UNITED STATES PATENT AND TRADEMARK OFFICE

APPLICATION NO.	FILING DATE	FIRST NAMED INVENTOR	ATTORNEY DOCKET NO.	CONFIRMATION NO.
09/990,739	11/16/2001	David H. Harris	5087-27	3310

Office Action Summary	Application No. 09/990,739	Applicant(s) HARRIS ET AL.	
	Examiner Khanh Dang	Art Unit 2111

DETAILED ACTION

Fig. 1 of Kobayashi:

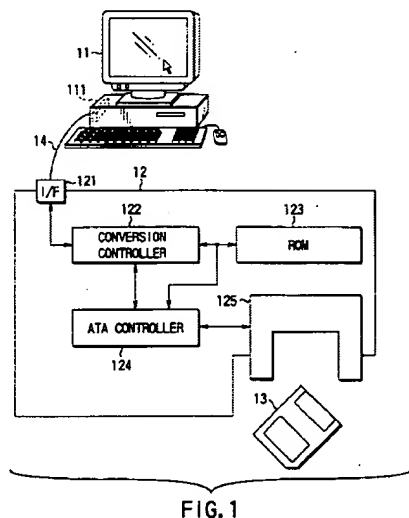
In other words, the difference between the claimed subject matter and that of Kobayashi resides on the fact that the in Kobayashi, the single chip conversion controller 122 resides on the motherboard of the storage device 12, whereas in the instant application, the conversion controller or "bridge circuit" (as claimed in claim 5) is provided on a separate or "secondary" board.

Note that the single chip conversion controller 122 or the so-called "bridge circuit" is provided on the motherboard of the storage device 12.

Fig. 2 of the instant Application:

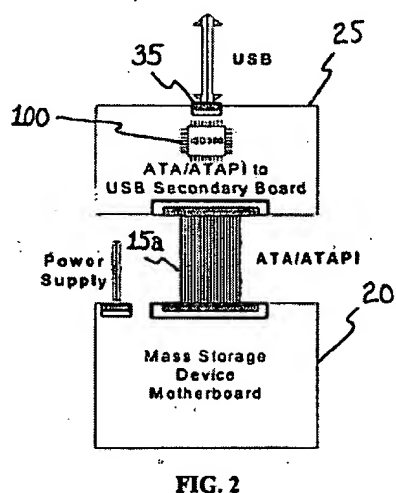
Note that the so-called "bridge circuit" (single chip) 100 is provided on a separate "secondary" board 25, instead of on the motherboard 20 of the storage device.

FIG. 3

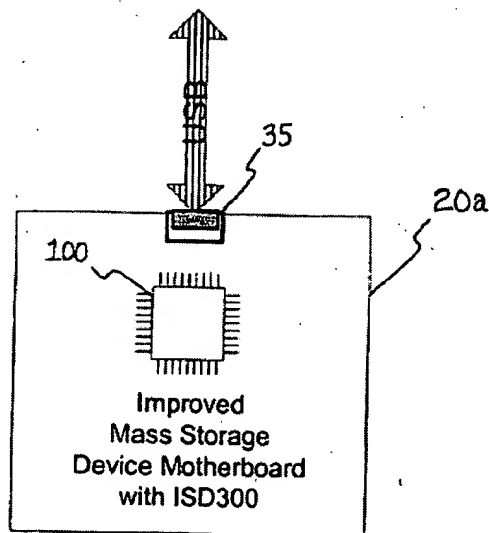
However, it is clear that whether the single chip conversion controller 122 or the so-called "bridge circuit" is provided on the motherboard of the storage device as in Kobayashi, or provided on a separate or "secondary" board as in claim 5, the conversion controller 122 would perform the same function, which is a function of converting between the ATA/ATAPI protocol to the USB protocol and vice versa. As matter of fact, as disclosed in Applicants' summary of the Invention, the crux of Applicants' claimed invention is a single bridging chip for converting ATA/ATAPI protocol to USB protocol and vice versa. The bridging circuit/chip 100 would perform the same function whether the bridging chip 100 is provided on a motherboard of the storage device (page 2, lines 8-12 of the originally filed specification, and Fig. 3):

FIG. 2

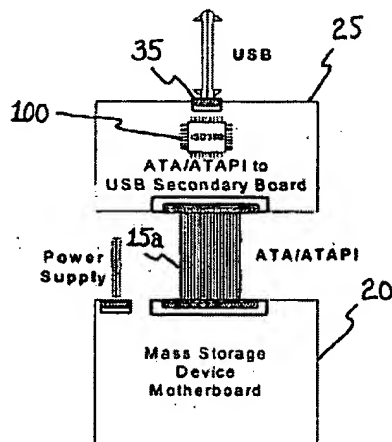
or, alternatively, as a design choice, the bridging chip 100 is provided on a secondary board (see page 2, lines 17-21 of the originally filed specification, and Fig. 2)

Thus, it would have been obvious to one of ordinary skill in the art at the time the invention was made to use a separate or "secondary" board for the single chip conversion controller 122 of Kobayashi, since the conversion controller chip 122 of Kobayashi would perform the same function whether on the same board with the storage device 12 or on a separate or "secondary board" and, thus, providing a separate or "secondary board" for the single chip conversion controller 122 of Kobayashi is a matter of design choice, as also acknowledged by Applicants, and only involves ordinary skill in the art.
